# PHOENIX-MESA GATEWAY AIRPORT

## EAST AREA AIRPORT MASTER DRAINAGE PLAN

## REPORT REVIEW COMMENTS & RESOLUTION FORM

Submittal: Pre-Final Master Plan Report

Figure 2 – Project Vicinity Map

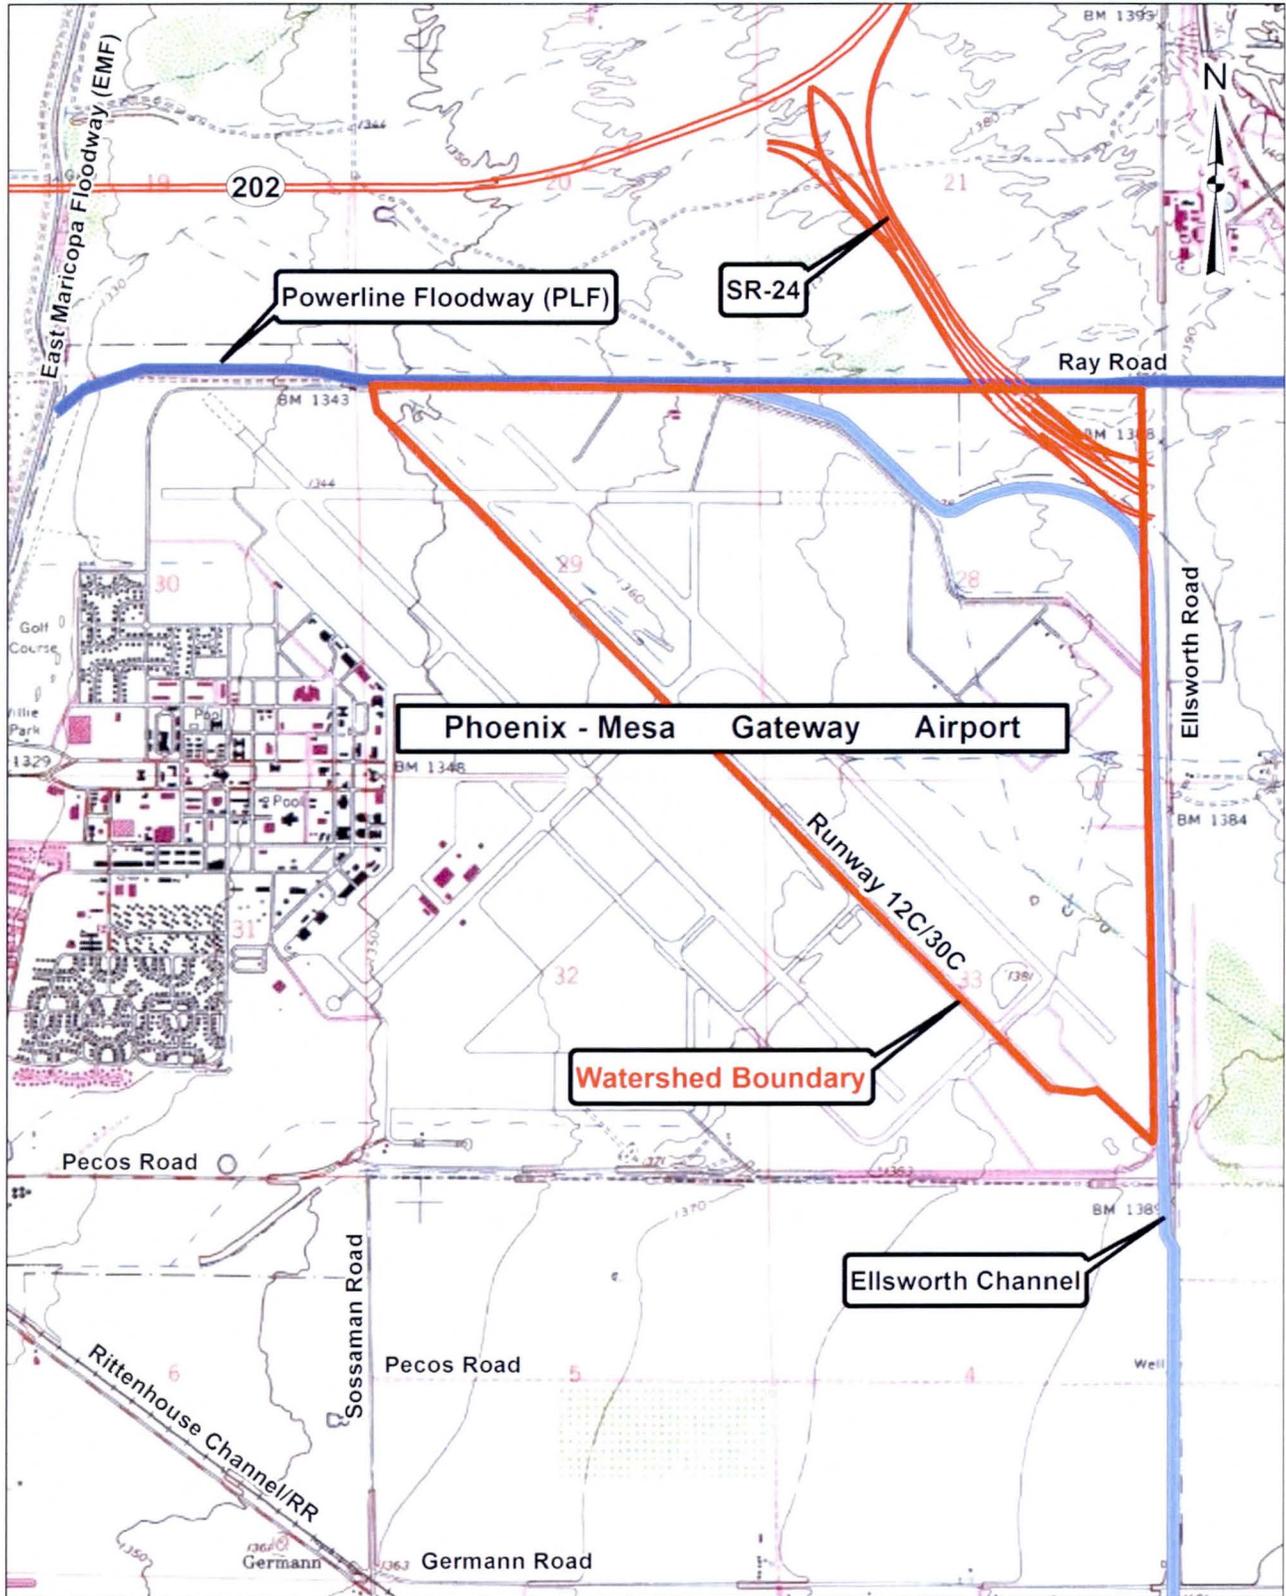
6	COM	BD/LW	6	Page 16, 22, 24	Study area in the existing condition needs to be consistent with the proposed conditions. Such as SR 24 being built in order to reflect apple to apples conditions.	D	See Comment #3.	
7	COM	BD/LW	7	Page 23	All alternatives include the moving of the Ellsworth Channel. Need to explain that this is necessary to allow development of the new terminal at the airport	D	This was mentioned in Section IV.C. It has been further clarified that the PLF and Ellsworth Channels are necessary for the new terminals.	JTB
8	COM	BD/LW	8	Page 35	Explain the improvements anticipated at the PLF. Improvements will be limited "by others" in the SR24 ADOT Construction Plan Set. What improvements are you alluding to other than the actual crossing of the SR24 area?	A	Discussion of the PLF improvements from the existing confluence to the new connection with Ellsworth upstream has been added to the text along with an estimated improvement cost.	JTB

Figure 5 – Proposed Conditions Watershed Map (Build-out Conditions)

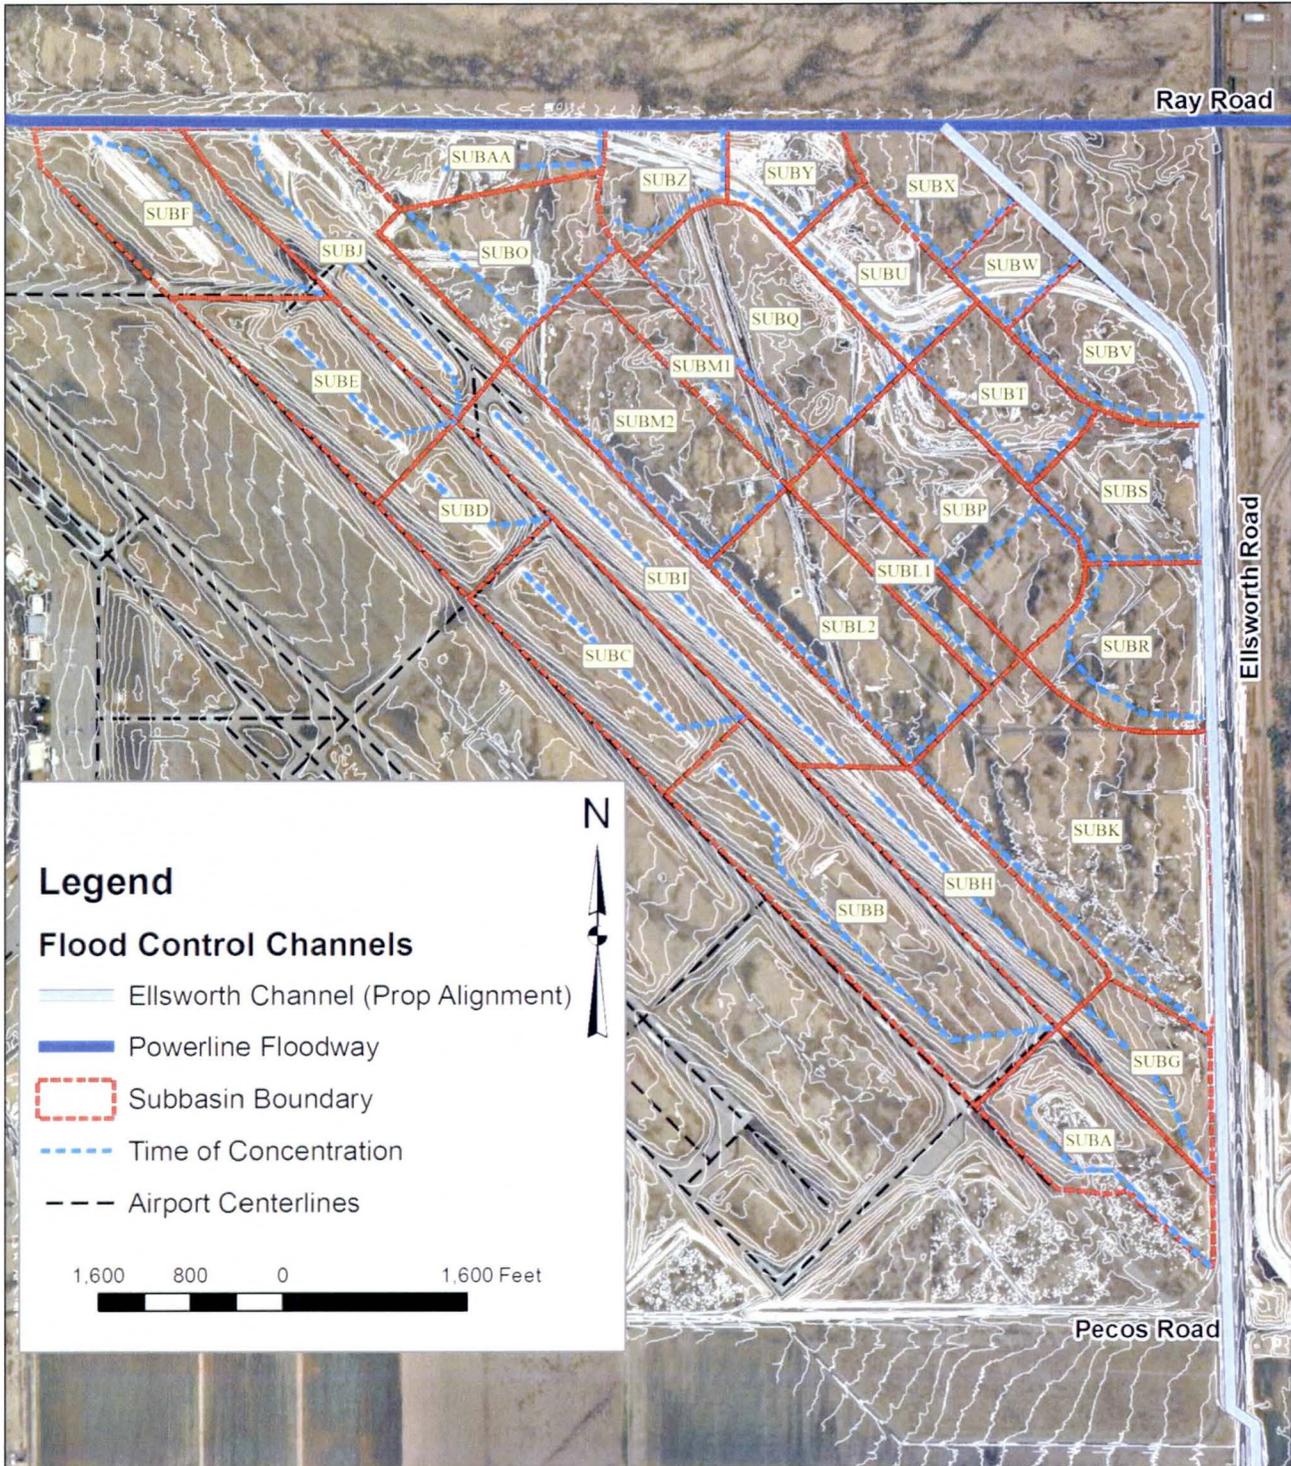
Item No	Agency	Reviewer	Comment No	Location (Sheet/DWG No)	Review Comments	Disposition Code	Response	Responder
1	COM	BD/LW	1	TOC-i	Fix spelling for "DRAINAGE" on the heading	A	Will revise text	JTB
2	COM	BD/LW	2	Page 1	Be consistent with DMP, AMDP, ADMP, etc. - FIX	A	Will revise text	JTB
3	COM	BD/LW	3	Page 16	The drainage area (SUB O) that includes the new freeway should consider this break in the watershed so existing conditions and proposed conditions can be matched up.	D	The existing conditions hydrology model was based on the project study area provided by the client. The future conditions model is based on future conditions with the future SR-24 in place and the drainage areas do not match.	JTB
4	COM	BD/LW	4	Figure 3	Call Figure 3 "Existing Conditions Watershed Map prior to Freeway Development"??	A	Will update exhibit title	JTB
5	COM	BD/LW	5	Page 22 & Figure 5	Call Figure 5 "Proposed Conditions Watershed Map" ??	A	Will update exhibit title	JTB
